## 15.0 PARTIAL RECIRCULATED DRAFT EIR COMMENTS AND RESPONSES

This chapter contains responses to each of the comment letters submitted regarding the Tierra Robles Planned Development Partial Recirculated Draft EIR (RDEIR). Similar to the comments and responses on the 2017 Draft EIR, each bracketed comment letter is followed by numbered responses to each bracketed comment. The responses amplify or clarify information provided in the RDEIR and/or refer the reader to the appropriate place in the document where the requested information can be found. Comments that are not directly related to environmental issues (e.g., opinions on the merits of the project that are unrelated to its environmental impacts) are either discussed or noted for the record, as appropriate. Where revisions to the RDEIR text are required in response to the comments, such revisions are noted in the response to the comment and are also listed in the Errata section of the Executive Summary for this Final EIR. All new text is shown as underlined (example) and deleted text is shown as strike through (~~example~~).

Re: Proposed Tierra Robles Planned Development Project

Below is a portion of Figure 3-14 from the EAGSA Draft Ch 3 page 3-12, published Sept 22, 2020 which was not included in the RDEIR. The two closest wells to the CCCSD wells are 29N/05W-11A02 and 29N/04W-04R03.

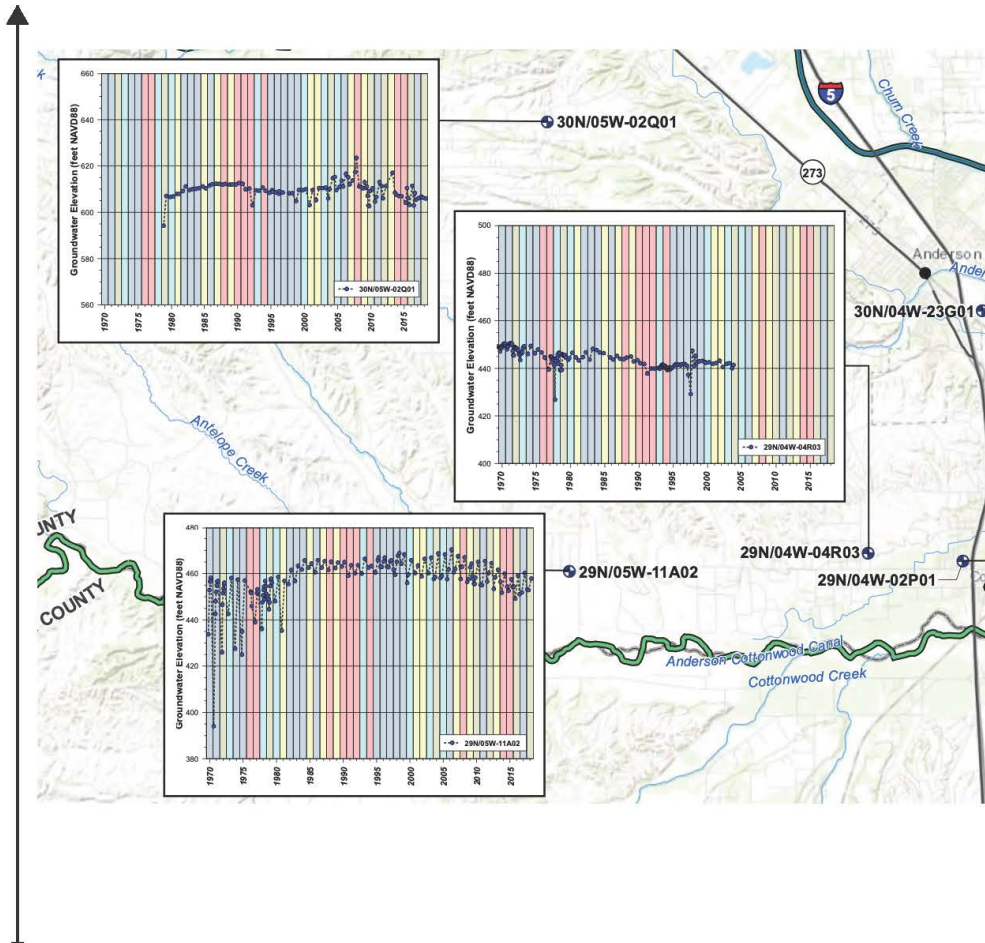
FIGURE 5.17-4 does not show well 29N/05W-11A02 or any well located within a mile of CCCSD wells. It also does not show any data for the well 29N/05W-11A02. Figure 5.17-4 is of the Enterprise Sub Basin and is many miles from the CCCSD wells. Using the correct Figure from the EAGSA Draft Chapter 3 Figure 3-14 for the location of the wells being discussed above. Chapter 3 states that groundwater levels at well 29N/05W-11A02 have been more variable over time but relatively consistent since 1985. However, during the drought years between 2007 and 2015 this wells groundwater levels decreased approximately 10 feet. How can the RDEIR state that the pumping by CCCSD has not had a notable effect on local groundwater conditions? Before pumping an additional 100 afy the water levels dropped 10 feet. What is the estimate, when during drought years, an additional 100 afy would be pumped?

During the 3 drought years that CCCSD pumped groundwater they averaged 284 afy and CCCSD would add approximately 35% additional pumping. If 284 resulted in a 10 foot drawdown, how much would 384 drawdown the same well? Won’t this also lead to greater fluctuations in water level due to pumping during the months that are already dropping in water level?

Groundwater levels in most of the wells shown on Figure 3-14 depict some influence from droughts and wet periods. Groundwater levels in groundwater wells 29N/04W-02P01, 29N/05W-11A02, 30N/04W-23G01, and 30N/05W-02Q01 are responsive to multi-year wet and dry periods. The intermittent droughts between 2007 and 2015 had a large impact on groundwater levels in 29N/05W-11A02, 30N/04W-23G01, and 30N/05W-02Q01, with groundwater levels decreasing by approximately 10 to 20 feet during droughts.”

The commenter reiterates comments about adjacent wells and their capacities. The commenter cites Figure 5.17-4 that does not include adjacent wells and questions how the RDEIR states the CCCSD pumping has not had a notable effect on ground water conditions and notes that the additional 100 AFY would drop it further.

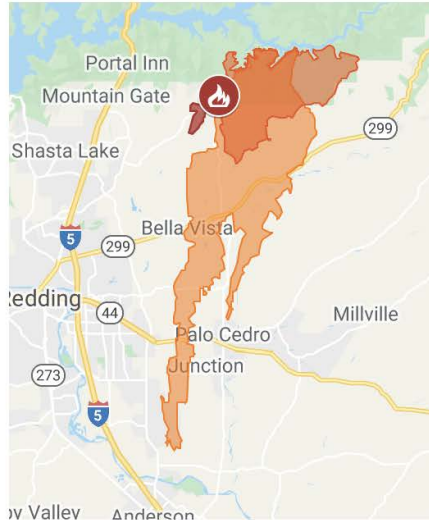
Copied from the RDEIR page 5.19-13/14  
“Emergency Evacuation  
These locations are open facilities that are accompanied by large unvegetated parking areas and they can reasonably be relied upon to be available in the event of an emergency evacuation. These potential temporary refuge areas are listed below and shown in FIGURE 5.19-3, TEMPORARY REFUGE AREAS.  
These areas include:  
1. Shasta College  
2. Crossroads Baptist Church  
3. Deschutes Road at CA 299 Shopping Center  
4. Foothill High School  
5. Deschutes Road at Old 44 Shopping Center  
6. Old Oregon Trail at Old 44 Business Center  
7. Columbia Elementary School  
8. New Life Church of God”

Two of these (2 and 8) refuge areas have parking for less than 70 cars each. Two (2 and 4) are one way in and one way out. Two (2 and 3) are only a few hundred yards apart but considered two separate areas. Expecting these locations to be used in the event of a wildfire evacuation is unrealistic and unsafe. The author of the evacuation study states that over 8500 vehicles will be evacuating the area. Imagine if Foothill High School was to be filled with evacuated vehicles and the fire that caused the evacuation continued s/b and required Foothill to be evacuated. The ensuing chaos of trying to get a jumble of disorganized vehicles out of this “refuge” could be catastrophic with hundreds of people and vehicles trapped. If anyone believes that this is an unreasonable scenario, I ask them to examine the 1999 Jones Fire. If anyone had evacuated to Foothill HS they would have then had to evacuate it very quickly or risk being overrun by the fast moving fire from the north. The 3.5 hours just to get from Tierra Robles to Foothill HS could have been a death sentence during the Jones Fire.

The comment cites pages 5.19-13 and 5.19-14 of the RDEIR and emergency evacuation, Figure 5.19-3, that the refuge areas are unsafe, and that the scenario is unreasonable, and that the 3.5 hours evacuation time is a death sentence. The commenter is referred to **Master Response #2** regarding the evacuation times evaluated in the RDEIR.
